The removal of Figure 4 necessitated changing Figures 5-8 along with changes in the specification. Also included are changes to correct for minor errors.

Version With Markings To Show Changes Made

FIG. 1

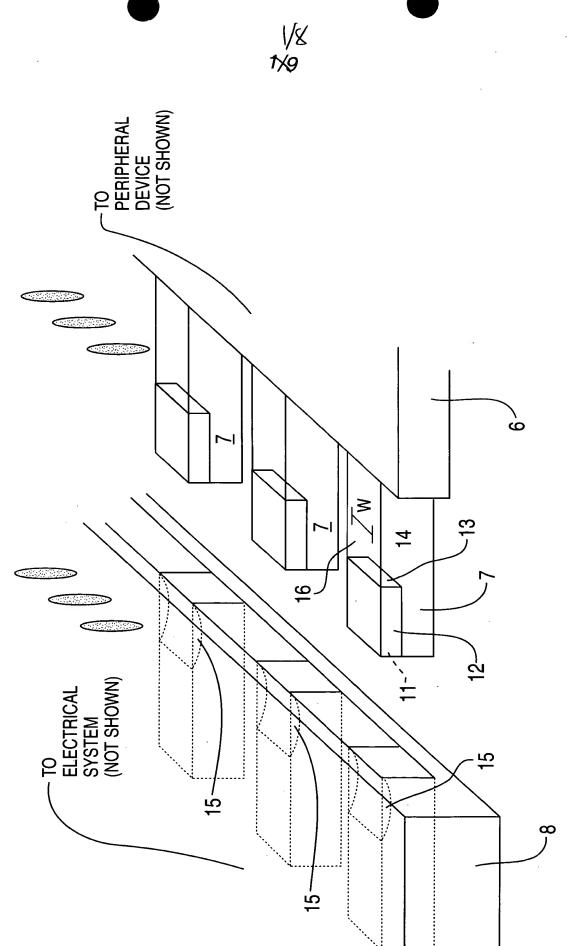
Substitute the following paragraph for the paragraph beginning at page 5, line 28: Referring to **Figure 1**, the preferred embodiment of the connector assembly of the present invention comprises a plug 6 for mating with a corresponding receptacle 8. It should be recognized that although only one plug contact 7 is shown in detail for simplicity, there are typically at least two or more plug contacts 7 within every plug 6 for mating with corresponding receptacle contacts **15**. The shape of the plug **6** is not central to the present invention. For simplicity, the plug 6 and plug contact 7 are illustrated as rectangular, although those of skill in the art will realize that many other shapes could be used without departing from the spirit of the present invention. The plug contact 7 comprises a conductive portion 14 which can be made from any conductive material, (such as brass, nickel, gold, copper or a superconductor, etc.) and a highly resistive portion 12. The resistive portion 12 is generally rectangular shaped and extends across the width **W** of the plug contact **7**. The resistive portion **12** comprises a layer of

highly resistive material inset into the surface **16** of the plug <u>contact **7**</u> [**6**], with a first end **11** of the resistive portion **12** exposed to the receptacle **8** and a second end **13** of the resistive portion **12** in contact with the conductive portion **14**.
